CERTIFICATE OF APPROPRIATENESS

Property: 2903 Houston Avenue, Tract 1, Block 2, Woodland Heights Neighborhood Subdivision. The property includes a historic 1,920SF, two-story wood single-family residence and detached garage situated on a 6,000 SF (50' x 120') interior lot.

Proposal: New Construction – Garage or Carport

The applicant is proposing to demolish the non-contributing garage and to build a 760 SF two-story garage and garage apartment.

3D RENDERINGS

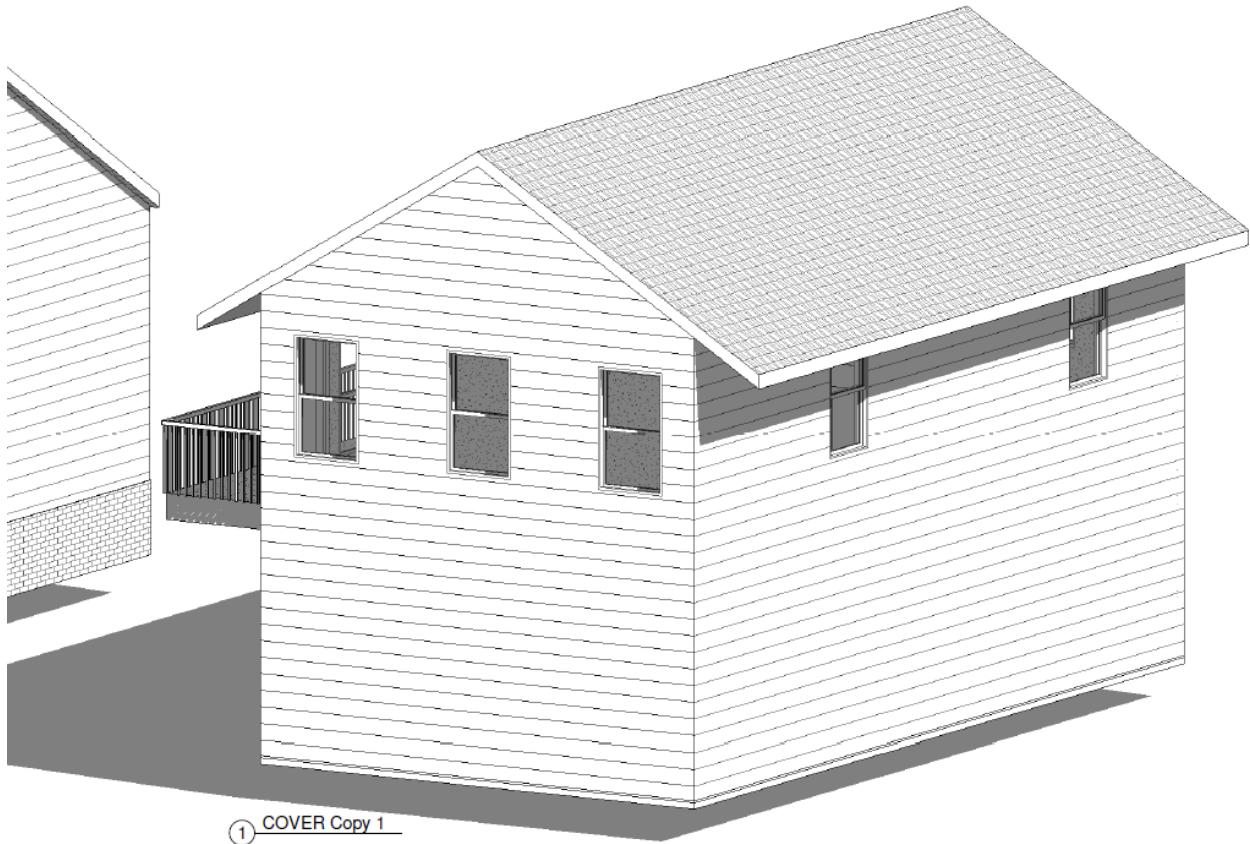
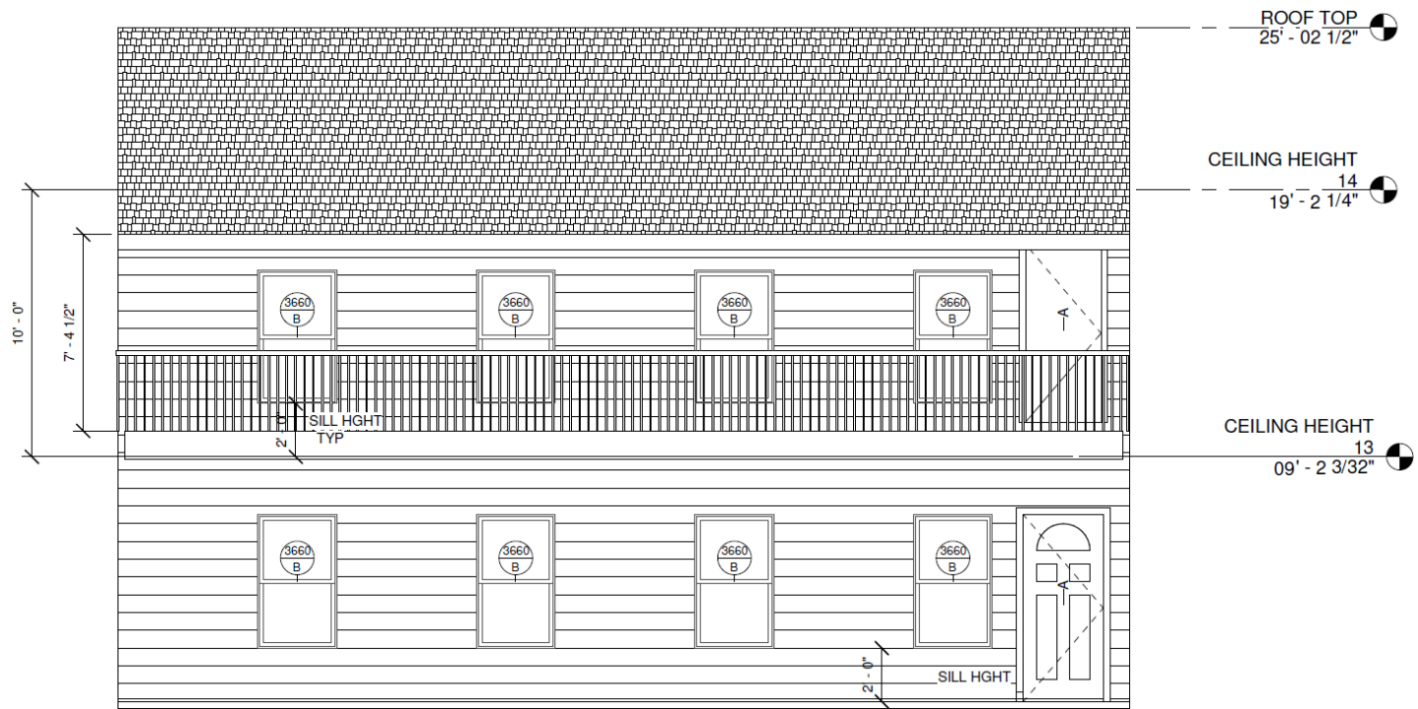
- **The plans he presented to me appear to be designed in the same architectural "bungalow" spirit as the home** (siding, trim, windows, roof covering type); as the Germantown Design Guidelines state that "garages should be constructed in a style and with materials that complement the house". THIS WAS THE INTENTION OF ESTABLISHING OUR HISTORIC DISTRICT.

- The front of the home has an east-facing porch that stretches the width of the entire structure – the garage will mimic that design with the exact same porch which will also face east. I've also included photos (below) of garage apartments within 2 blocks of Mr. Ries home for comparison of garages designed with porches to match the style of the home.
- The garage roof pitch should match the home.
- All garage doors should match the style of the doors on the home (Craftsman).
